DRAFT AEROTROPOLIS PRECINCT PLAN
SUBMISSION BY THE LUDDENHAM LANDOWNERS
CONSORTIUM

DRAFT AEROTROPOLIS PRECINCT PLAN

This submission is prepared in response to the exhibition of the *Draft Aerotropolis Precinct Plan* on exhibition by the *Western Sydney Planning Partnership*.

This submission is made by the **Luddenham Landowners Consortium** (LLC).

Above – The LLC landholdings on western edge of airport and outside of Metropolitan Rural Area. Hatched area shows MRA for remainder of Agribusiness Precinct. Source: *Metropolitan Rural Area Exclusion Map – SEPP Seniors Living (Liverpool Map)*.

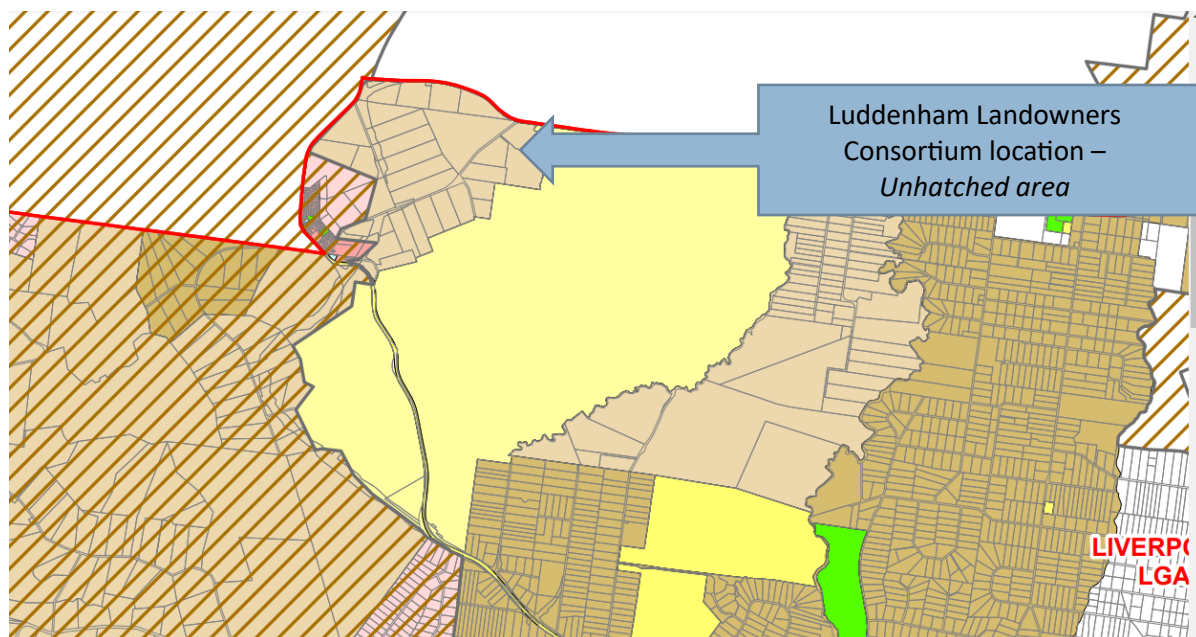
The LLC is the **only part** of the *Agribusiness* Precinct and Agribusiness Zoned land that is **NOT** within the **Metropolitan Rural Area** (MRA) identified by the Western City District Plan.

The LLC is also the **only part** of the *Agribusiness* Precinct and Agribusiness Zoned land that was previously clearly identified as **future employment lands** within the previous *State Environmental Planning Policy (Western Sydney Employment Area) 2009*. No other Agribusiness zoned land was identified clearly as being *future employment land*.

The LLC landholdings were also subsequently the **only area** identified within the **Western Sydney Priority Growth Area**. The LLC landholdings were taken out of this *WSEA SEPP* by the *Aerotropolis SEPP*, and now form part of the *Agribusiness* Precinct along with other lands not originally identified for employment purposes (refer to LLC submission to the Dept. of Planning, Industry and Environment regarding the Mamre Road Precinct re-zoning under the *WSEA SEPP*).

The LLC have consistently been emphasising this distinction between our Consortia landholdings and the remainder of the *Agribusiness* Precinct in our submissions. We believe that being the only part outside of the MRA, and by being previously identified as clearly future employment lands under the *WSEA SEPP* and the Western Sydney Priority Growth Area, that a different town planning hierarchy must apply to this land as it is **distinct from the other Agribusiness zoned land** now included with our Consortium lands.

Above – The LLC landholdings on western edge of airport and the Western Economic Corridor (only location with the *Agribusiness* Precinct).

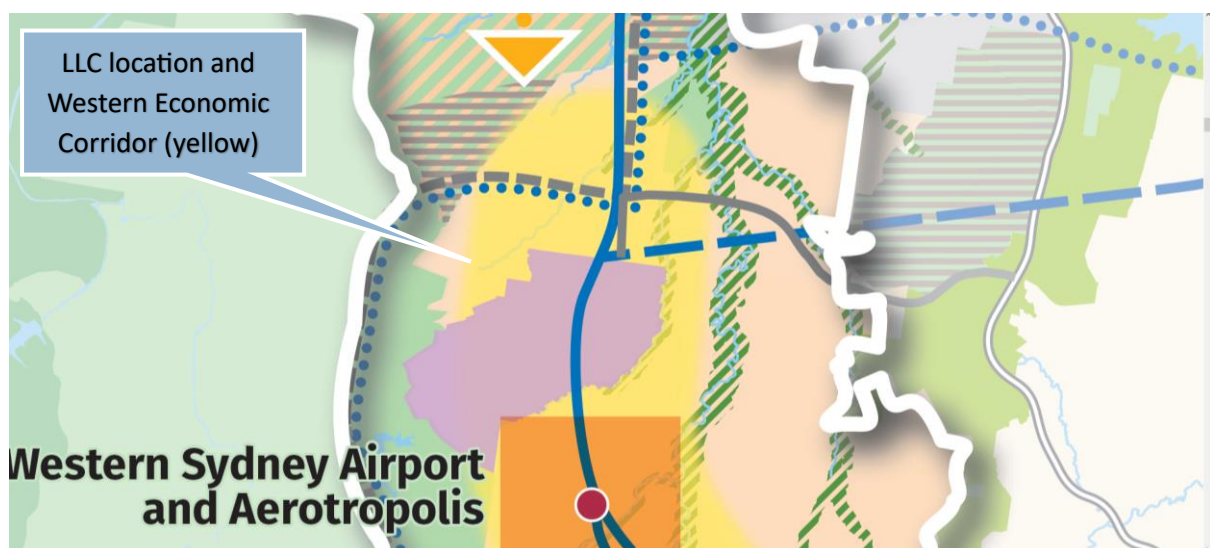
The eastern half of the LLC is also significantly the **only part** of the *Agribusiness* Precinct that is within the **Western Economic Corridor (WEC)** identified in the Western City District Plan.

The LLC agree with this statement and the *Draft Plan* should recognise the development of the WEC within its planning framework - something that the *Draft Plan* does not do.

The *Draft Plan* (and other concurrent documents such as the *Draft PIC*) should be amended accordingly to recognise that the LLC area was identified in the Structure Plan for the Western City District **as being distinct from the remainder of the Agribusiness Precinct** during earlier stages in the overall planning processes for Sydney and should have the same consistency and planning hierarchy offered to other precincts of the Aerotropolis.

The *Precinct Plan* should therefore be amended to provide for a land use hierarchy appropriate for this higher use of the land originally envisaged, as compared to the remainder of the *Agribusiness Precinct*.

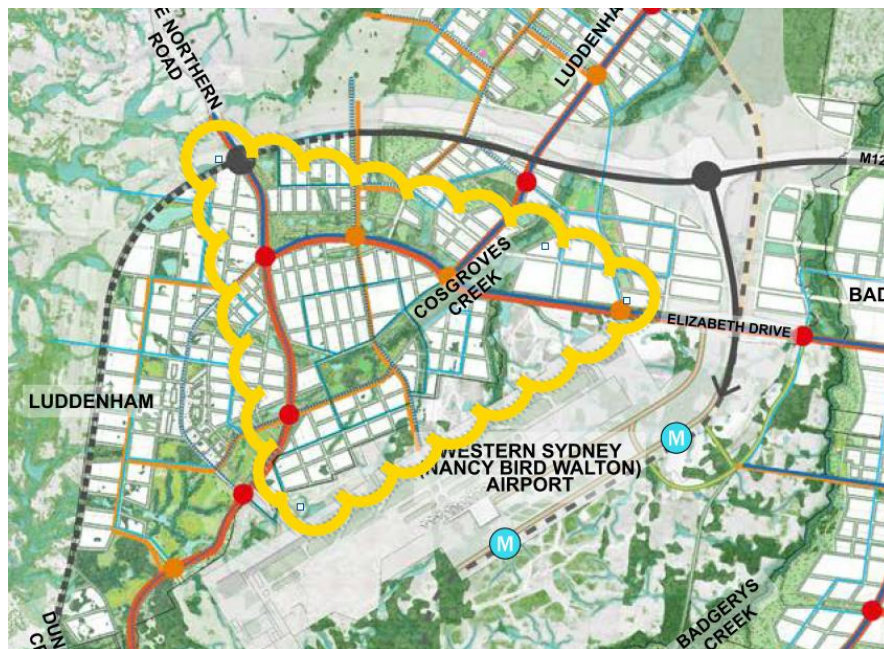
As shown in the *Active Transport Corridors* plan in Figure 20 of the *Draft Plan*, consideration for cycle path access to the WSA at Anton Road is proposed with a continuation of this path hinted in this diagram. This is shown in the extract on the following page (Principal Regional Cycle Path shown in purple).

It would only make sense that access to the Airport Terminal Station should be provided for both pedestrians and cyclists from this western boundary of the Airport.

As already stated, the *Draft Plan* (and the *Draft PIC*) does not address this potential for access to a Metro Station within the Airport site and the benefits that this could provide, along with other road transport networks.

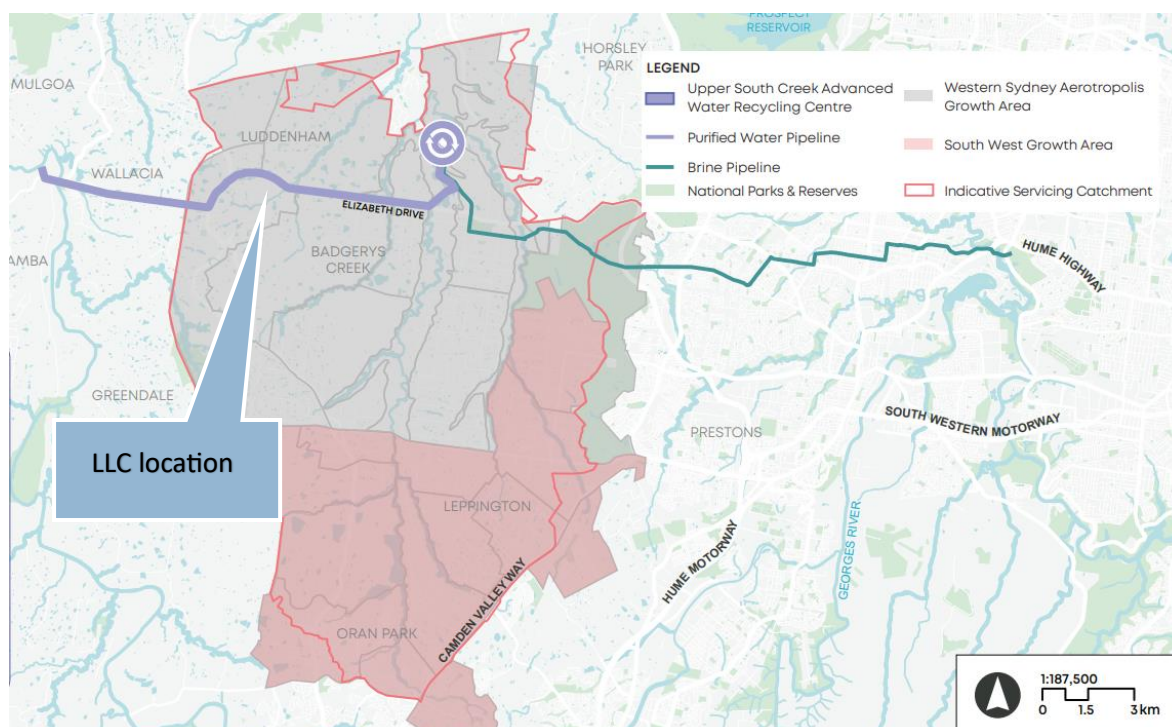
Being within the **same water catchment area** as the remainder of the Aerotropolis, the LLC area is poised for servicing and connections for water, sewer, and recycled water. The LLC area is wholly within the Wianamatta/South Creek Catchment area that enables water and sewer servicing, as compared to the majority of the *Agribusiness* Precinct which is outside of the Wianamatta/South Creek catchment area.

Sydney Water have also recently identified their new **Advance Water Recycling Centre** in Kemps Creek along Wianamatta-South Creek. The LLC area in relation to this proposed network is seen on the attached diagram on the following page, with the northern boundary of our area shown as being serviced by recycled water/purified water pipeline.

The sequencing plan for the LLC area is shown in the Figure 66 of the *Draft Plan* in Section 5. This sequencing plan is based on the *Draft PIC*.

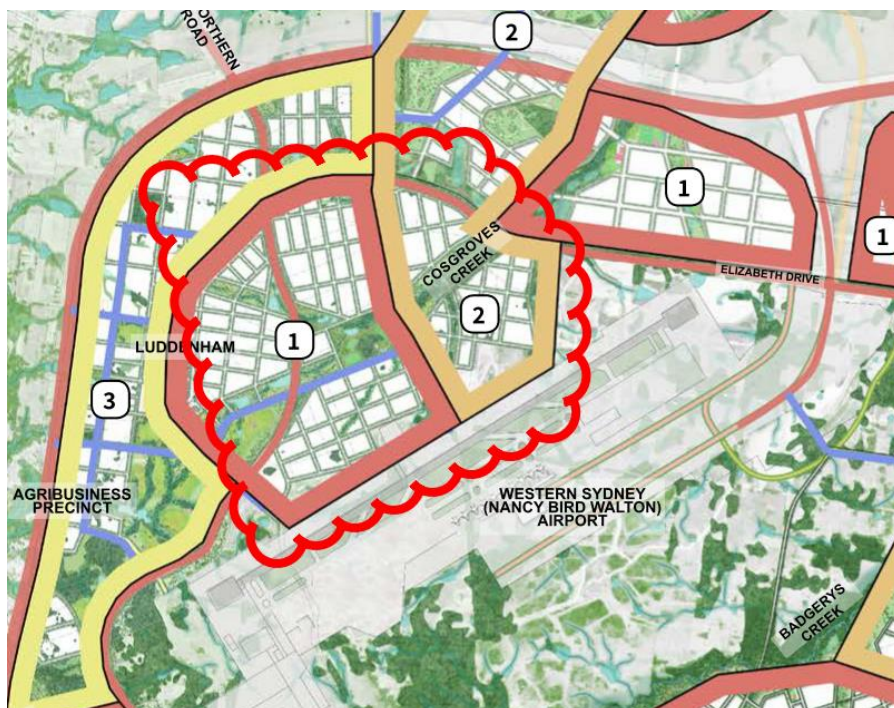
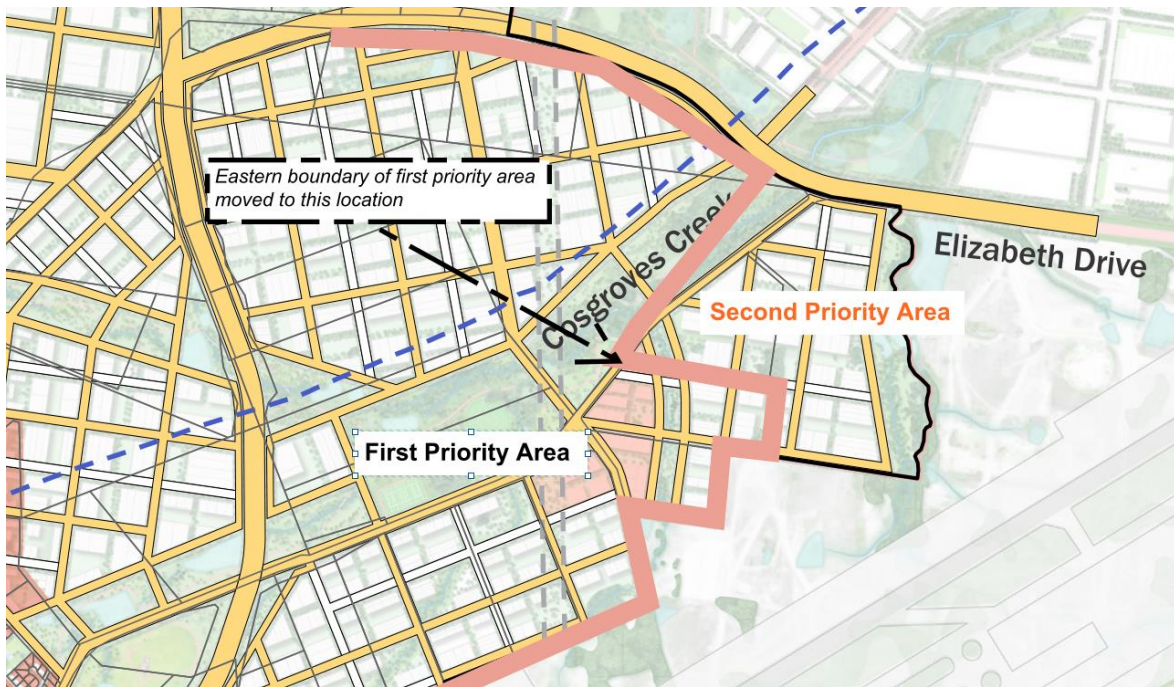
The LLC requested an **amendment to the sequencing plan** to the *Greater Sydney Commission* and similarly requests the *Western Sydney Planning Partnership* to amend this sequencing plan.

The reasons why this amended sequencing plan is favoured is as follows:

- The Sequencing Plan within the *Draft Plan* (and the *Draft PIC*) is not consistent with the Structure Plan adopted with the Western City District Plan. The amended Sequencing Plan shows consistency with the Western Economic Corridor (WEC) identified in the Western City District Plan and more aligns with the Structure Plan adopted with the Western City District Plan.

- The amended Sequencing Plan follows the Luddenham Landowners Consortium landholdings and all landholders agree on this submission. The LLC has endeavored to work with the NSW Government at all times in delivering the Aerotropolis and the envisaged *Agribusiness* Precinct. By placing this Consortium into two separate areas, further collaborative work with Government would potentially not be possible/cease.

The high-level sequencing arrangements for this area of the *Agribusiness Precinct* should be altered to align with an **amended sequencing plan** as shown below:

The *Draft Plan* should therefore amend the *Sequencing of the Initial Precincts* plan within in Figure 66 in the manner shown in this submission for better use of the land on the western boundary of the airport.
